BAW-10193NP-A

**RELAP5/MOD2-B&W For Safety Analysis of  
B&W-Designed Pressurized Water Reactors**

**SUBJECT: SAFETY EVALUATION OF TOPICAL REPORT BAW-10193P,  
"RELAP5/MOD2-B&W FOR SAFETY ANALYSIS OF B&W-DESIGNED  
PWRs" (TAC NO. M93346)**

SAFETY EVALUATION BY THE OFFICE OF NUCLEAR REACTOR REGULATION

Figure 3. HPI Flow Rates Recorded During the Rancho-Seco Loss of ICS Power Event And Used in BAW-10193

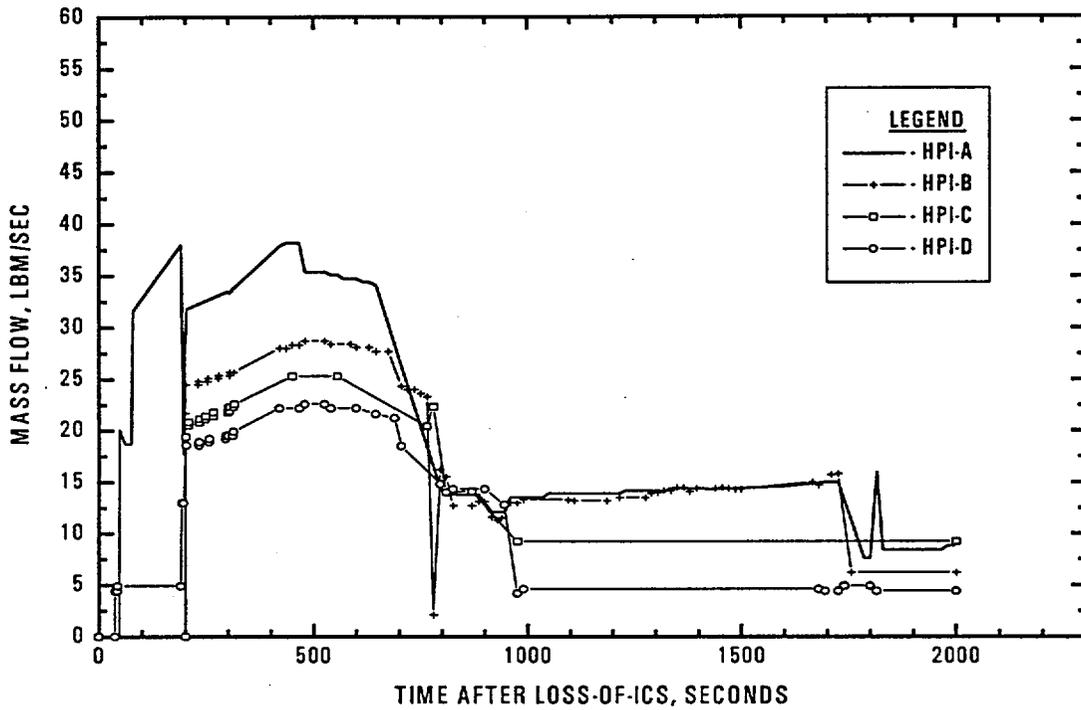
The code underpredicted the RCS repressurization, which FTG attributed to the uncertainty in measured HPI flows that were input in the benchmark calculation. In response to staff question 4 (Ref. 10), FTG reanalyzed RCS pressure response in the loss of ICS power event using an increased HPI flow. The results demonstrate that an increase in HPI flow has little effect on the pressure prediction during the depressurization because of the dominant effect of the RCS contraction caused by overcooling. However, once the cooling of the RCS was

Relative to the HPI flow measurement uncertainty, FTI did not perform a detailed uncertainty analysis. There is no accurate way to estimate the uncertainty. FTI inspected the HPI flow data (Figure 3) and reviewed the HPI system piping isometrics for Rancho-Seco. It appeared that the measured flow for the "A" loop was substantially greater than the other loops because the flow was delivered through an HPI nozzle as well as the make-up nozzle (lowered-loop B&W-designed PWRs use HPI pumps for normal makeup). There did not appear to be a good reason for the difference in flows between the "B", "C", and "D" loops. Therefore, the flows in the "C" and "D" loops were set equal to the values measured in the "B" loop (Figure 4) from the time of SFAS until the operator terminated flow in those loops (reported in the plant sequence of events as approximately 16.5 minutes). Reanalysis of the event yielded the pressure and pressurizer level predictions in Figures 5 and 6, respectively. Note that the pressure and pressurizer level predictions improve after 500 seconds, but prior to 500 seconds there is minimal change.

FIGURE 4-7. MEASURED AND PREDICTED PRIMARY OUTLET TEMPERATURES FOR THE 19-TUBE LOFW TRANSIENT.

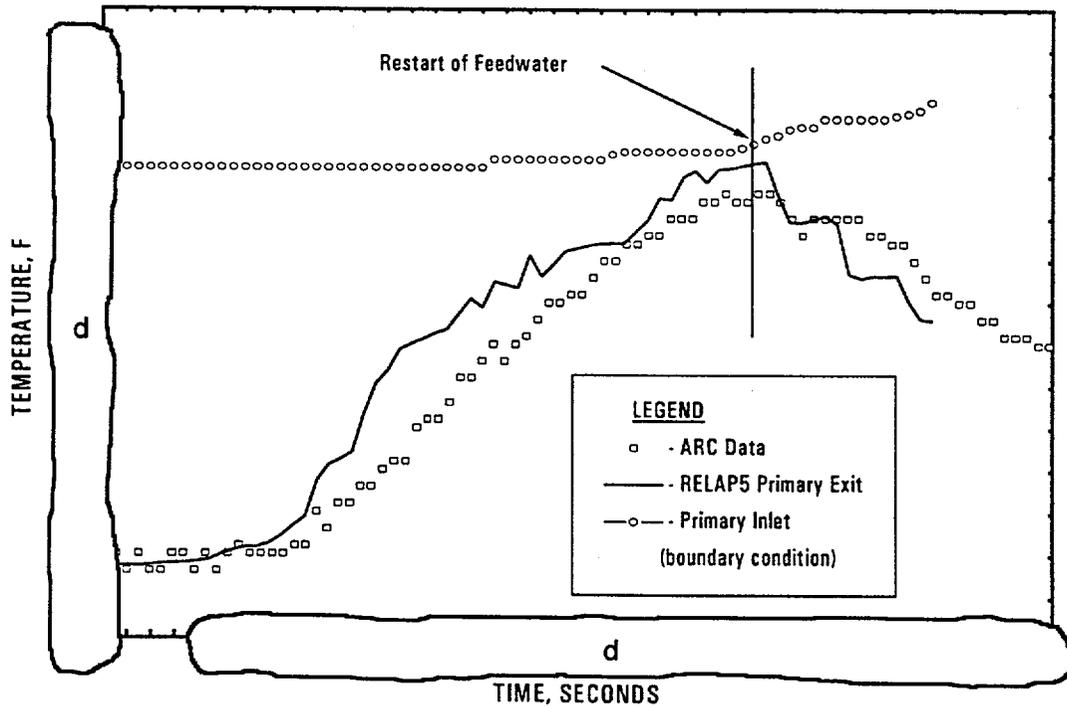
Figure 4-7 shows differences between the predicted and observed primary-side outlet temperatures. FTG attributed these differences to the heat capacity of the resistance thermal detector (RTD) used in the test. The RTD heat capacity caused a lag in the measured temperature response such that the actual fluid temperatures were higher than the recorded values during heatup and lower than the recorded values during the refill. In response to staff question 2 (Ref. 10), FTG performed a Laplace transform of the calculated primary-side outlet temperature to account for the RTD time constant. The adjusted temperature results show good agreement with the actual RTD output, demonstrating that, if a thermal lag were applied to the code prediction to account for RTD capacity, a good match would be obtained with the measured data. This indicates that the RELAP5/MOD2-B&W prediction of transient heat transfer is in good agreement with the test, as demonstrated by the good agreement between the predicted and measured steam flow. The benchmarks demonstrate that RELAP5/MOD2-B&W with the control volume arrangement used in this benchmark can predict the shell-side

FIGURE 4-10. MEASURED AND PREDICTED STEAM FLOW FOR THE 19-TUBE IEOTSG LOFW TRANSIENT.

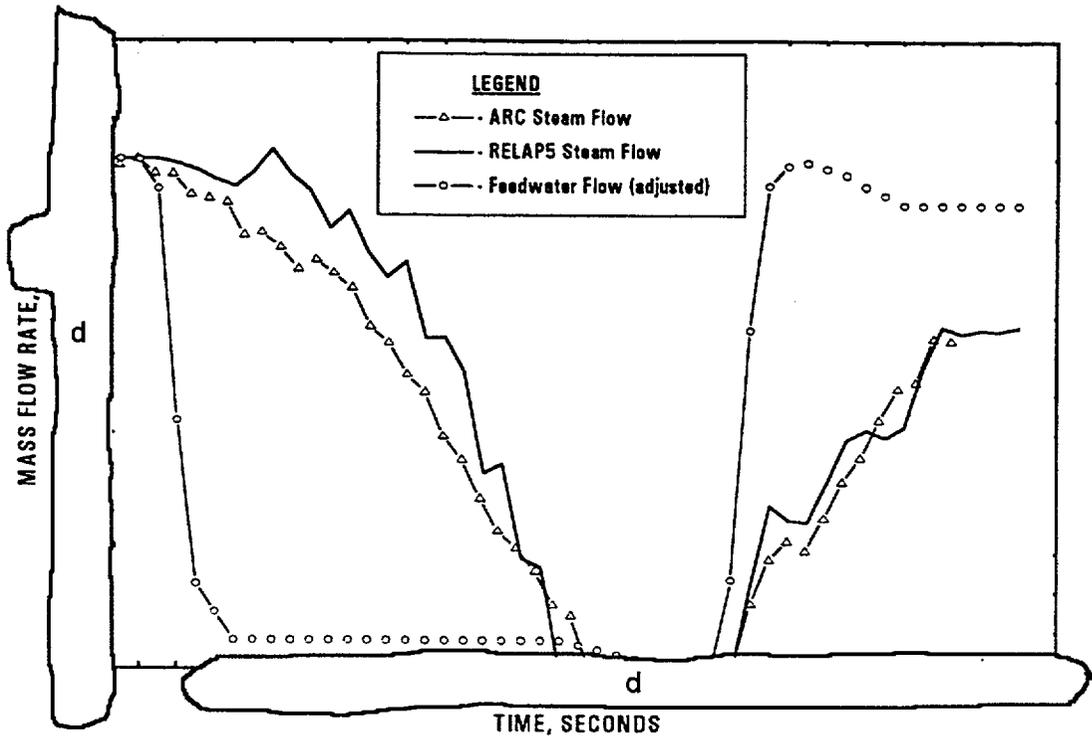
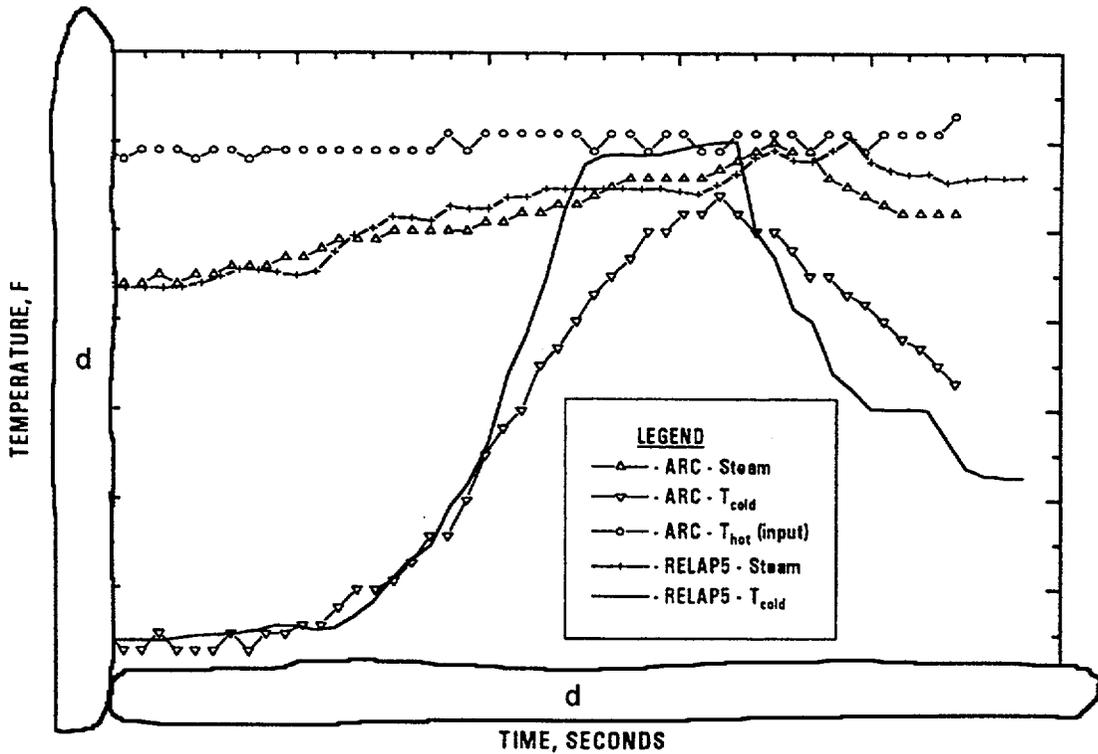
Figure 4-10 shows the code prediction of dryout time to be 2 seconds less than the observed time. This is because the code overpredicted the steam flow from the IEOTSG during the dryout period. This results in early dryout and a low prediction of primary outlet temperature caused by an overprediction in heat transfer. The overprediction of steam flow arose as the mixture level crossed the control volume boundaries. FTG concluded that the noding detail used to predict the IEOTSG test data is too crude to produce an accurate result and that additional modeling is required. FTG, in its response to staff question 2 (Ref. 10), indicated that the benchmark will not be refined at this time, because it has no plans to perform IEOTSG plant safety analysis. FTG stated that before (or concurrent with) the licensing submittal of an IEOTSG plant safety analysis, it will submit an updated benchmark of these test data for NRC review. The staff concludes that RELAP5/MOD2-B&W may not be used for the safety analyses of PWRs with IEOTSGs until FTG submits and the staff accepts an updated benchmark of the IEOTSG LOFW test case.

Figure 4-10 in BAW-10193 shows that there was a time delay between restart of feedwater and restart of steaming. If the downcomer pipe was full, as it should have been, then steaming would have started immediately upon feedwater restart. We postulated that the time delay observed in the test was the time required to refill the downcomer pipe to make up for the mass lost during the test. The mass lost from the downcomer pipe was estimated by multiplying the feedwater flow at 35 seconds times the time delay of about 1.5 seconds. The resulting mass [ c, d ] was transferred from the downcomer pipe to the tube bundle over approximately 22 seconds, as shown in Figure 4-10 of the topical report.

FIGURE 5-10. TEMPERATURE COMPENSATED PRESSURIZER LEVEL FOR THE TMI-2 LOFW EVENT.

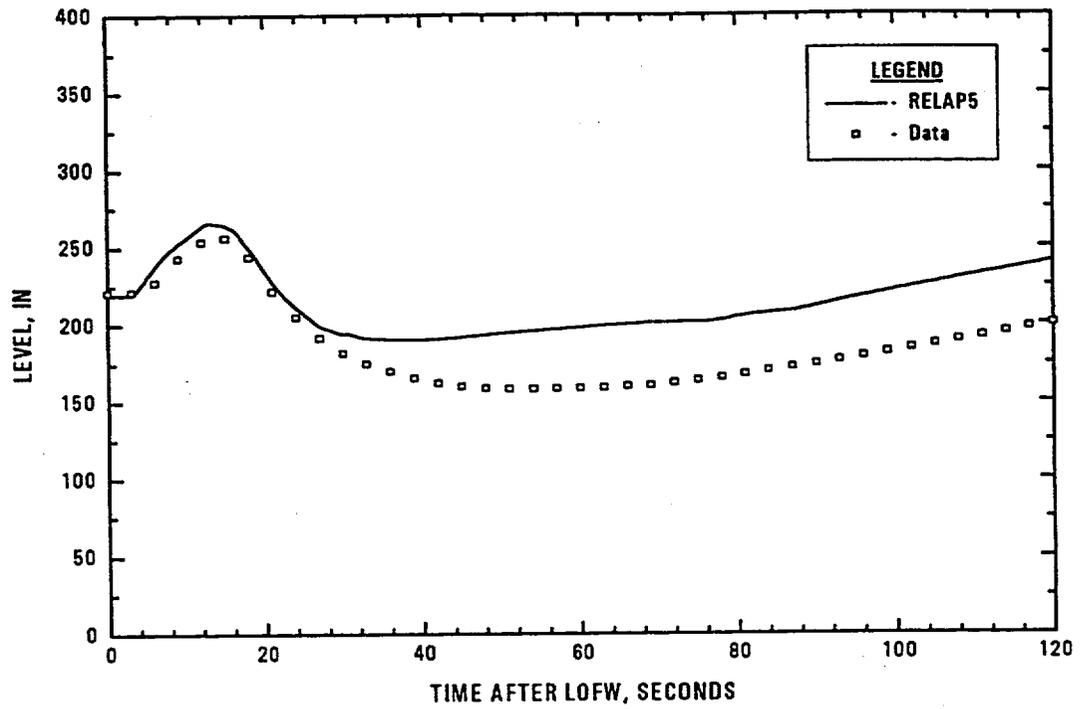
*Regarding the RELAP5/MOD2-B&W analysis of the TMI-2 LOFW event, Figure 5-10 indicated agreement between the code prediction of the pressurizer level and the plant data up to the reactor trip at about 20 seconds. After the reactor trip, the code overpredicted the plant data. You concluded, based on the experience with the B&W plants showing the pressurizer level should decrease by 5.5 inches for every degree decrease in average system temperature, that the plant data are probably not reliable during this period. Are the pressurizer level data prior to the reactor trip reliable, and why? What conclusion can one draw when the code predictions are in good agreement with the plant data if the data are not reliable?*

FIGURE 5-20. STEAM GENERATOR OPERATE RANGE LEVEL FOR THE TMI-1 NATURAL CIRCULATION TEST.

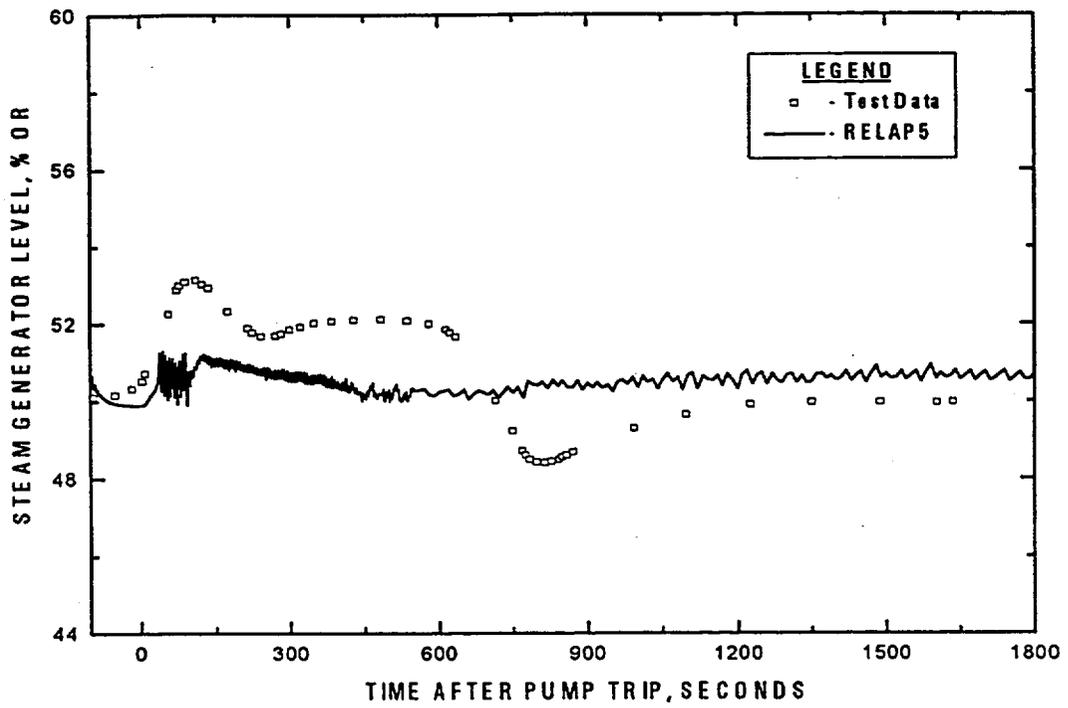
- B. *Explain why (1) the RELAP5/MOD2-B&W input of the setpoints shown in Table 5-14 for the pressurizer heater banks 3 and 4 are 15 psi lower than the plant setpoints, and (2) the input steam generator level boundary condition shown in Figure 5-20 is different from the plant data.*
